THE CITY OF KEY WEST  
PLANNING BOARD  
Staff Report

Application: **Variance** - 1317 Ashby (RE# 00044430-000000) - A request for a variance to the minimum front yard setback and the minimum rear yard setback in order to demolish an existing single-family home and construct a new single-family home to meet flood zone requirements on a parcel located in the Single-Family (SF) zoning district pursuant to Sections 90-395, 122-238(6)a.1., and 122-238(6)a.3.

Proposed Site Plans, submitted by applicant

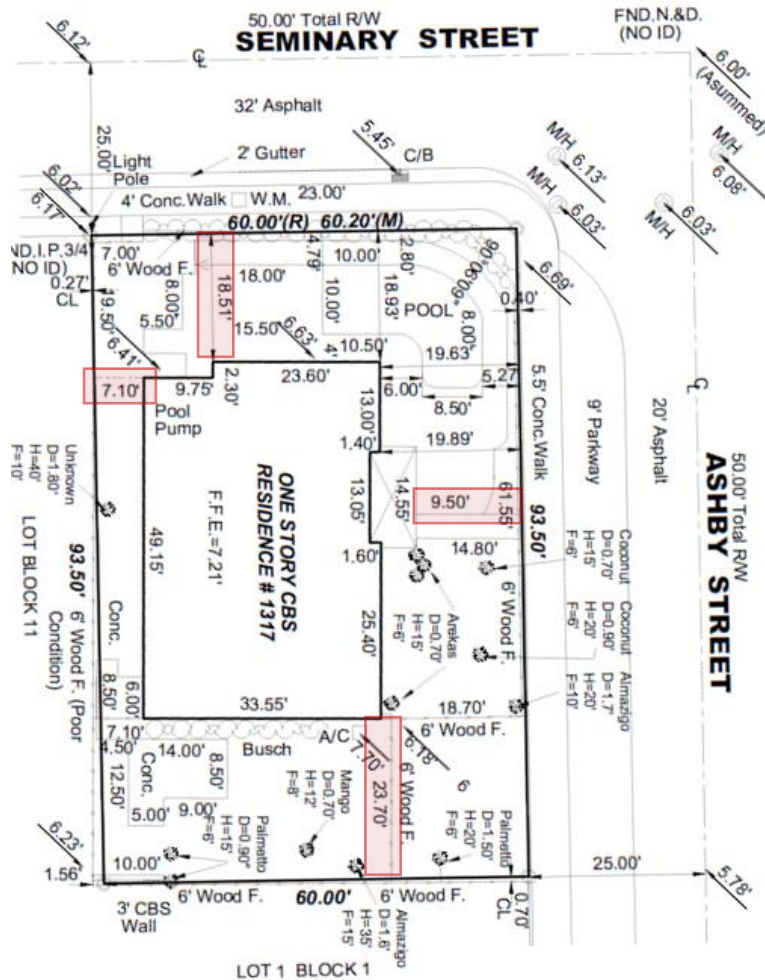
The applicant had applied for a building permit to demolish the existing single-story residence, leaving the slab and some exterior walls to remain. The applicant applied for an additional building permit to construct a two-story living structure above a parking/storage area. The applicant has chosen to design their proposed structure in order to meet the updated Base Flood Elevation of 10-feet. The applicant would meet the site dimension regulations for impervious surface, building coverage, and open space, however due to the lot's configuration on a corner, the applicant's proposed design does not meet the front and rear setbacks.

The site table below details the current and proposed site data for the property. Two variances are proposed for this development.

1 FIRST FLOOR PLAN  
A-03 SCALE: 1/4" = 1'-0"

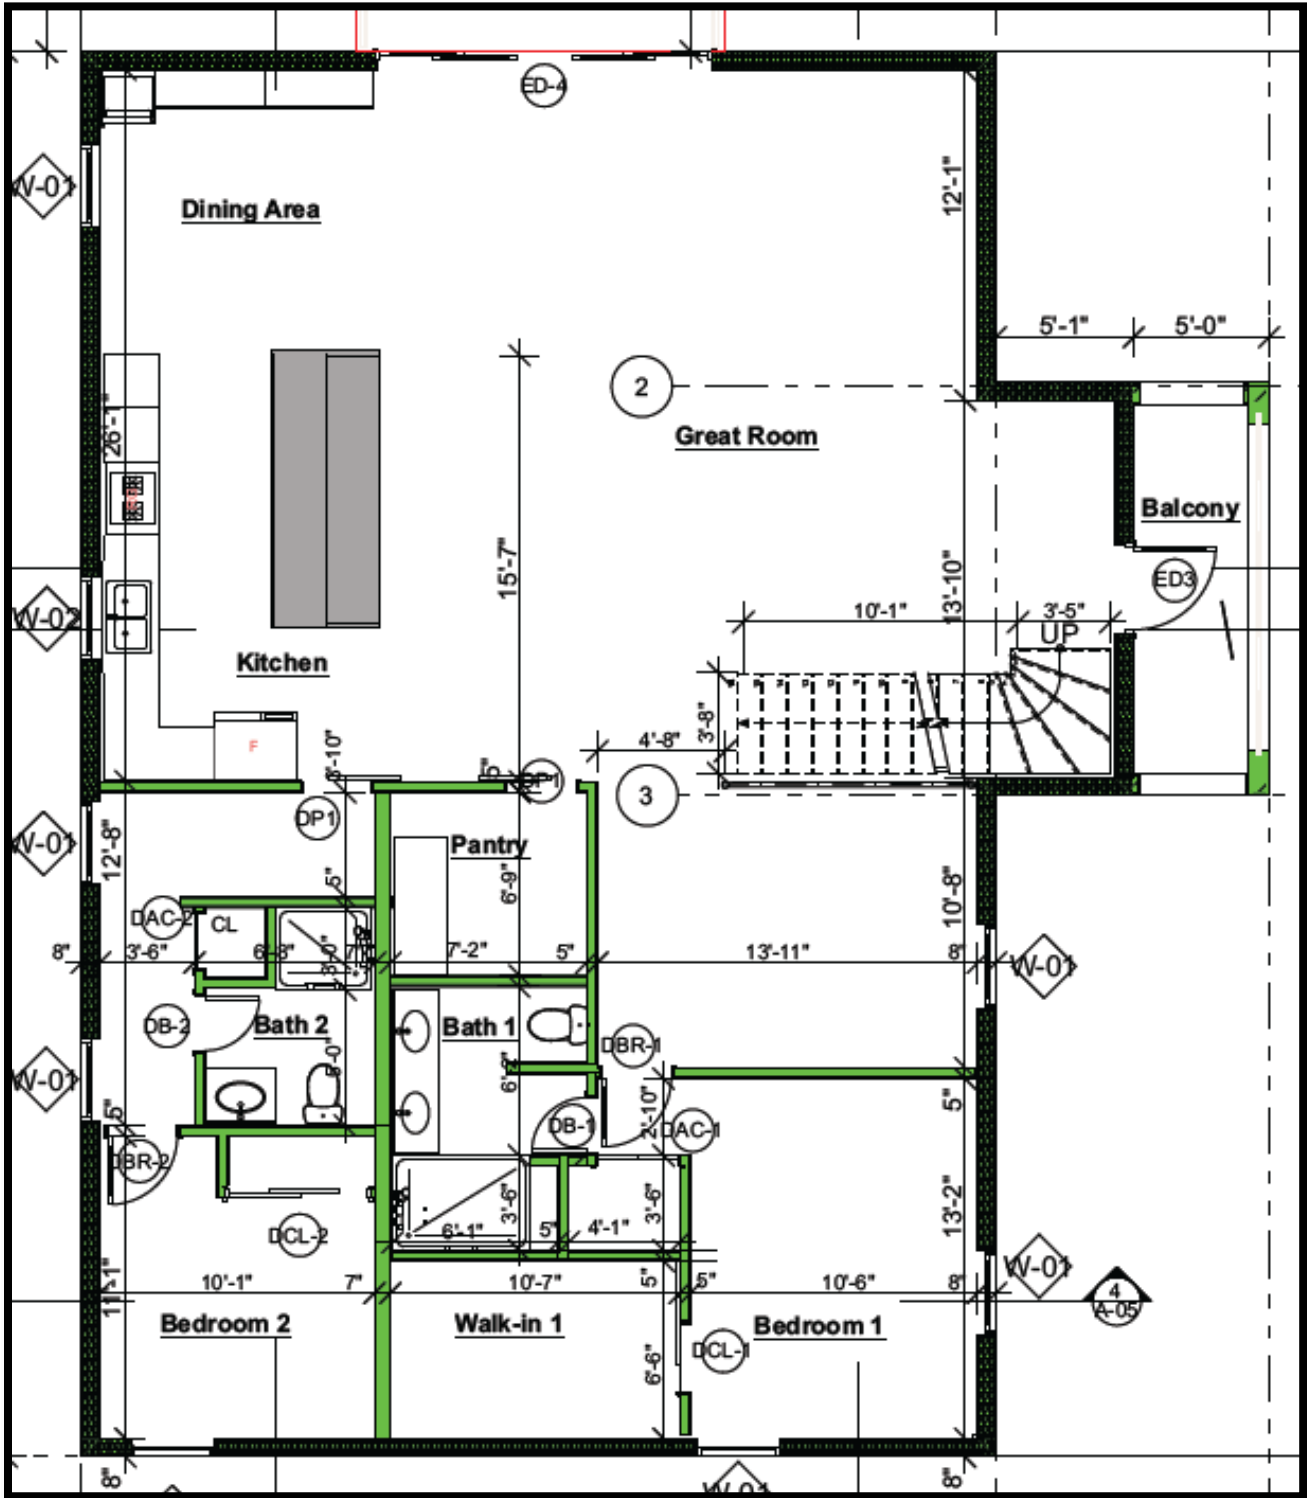
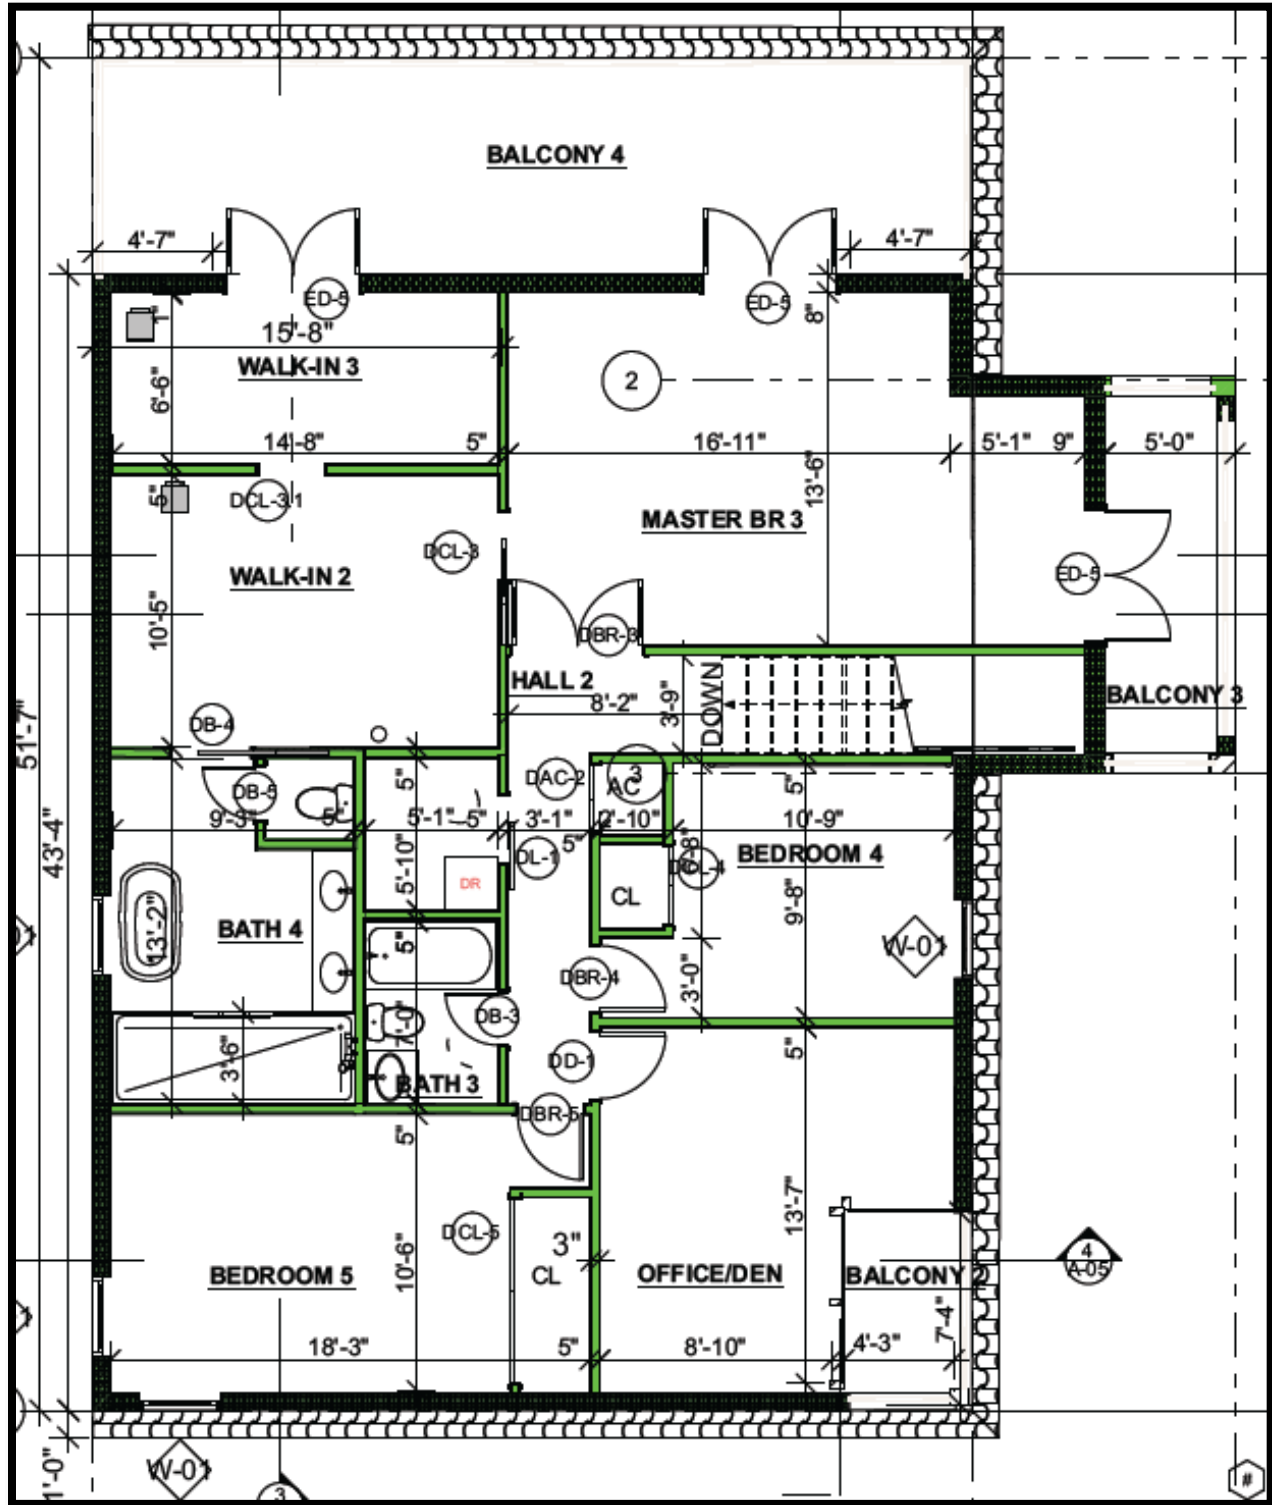
The proposed structure would still be constructed in the front and rear setbacks; however, the applicant has proposed to expand the rear of the house slightly further into the rear setback.

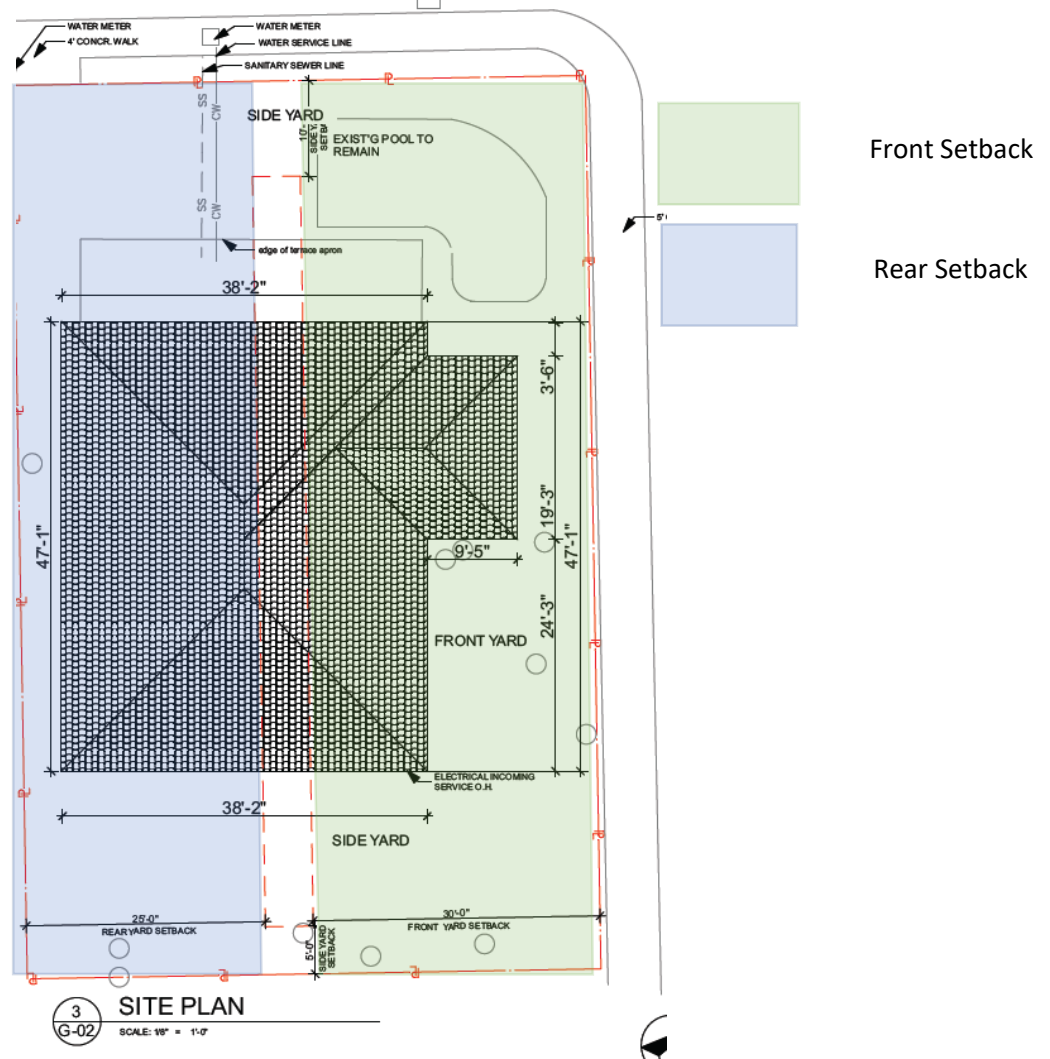
The parcel located at 1317 Ashby is smaller than code required minimum lot size. The Land Development Regulation's required setbacks are designed to provide open space around and between structures for health, safety and aesthetic purpose. Strict compliance with the minimum setbacks required for the SF zoning district would not pose a significant hardship on the applicant, however the applicant would have to demolish the existing structure and the existing slab and construct a new slab and create a longer house that would fit neatly into the lot, oriented toward Seminary Street, as seen in the diagram below:

If the lot were to be refaced/re-oriented and the address changed to Seminary Street, the proposed structure would still need a variance to both front and rear setbacks. However, a differently shaped structure could be compliant with setbacks. Literal interpretation of the provisions of the Land Development Regulations would not deprive the applicant of rights commonly enjoyed by other surrounding properties under the terms of this ordinance.
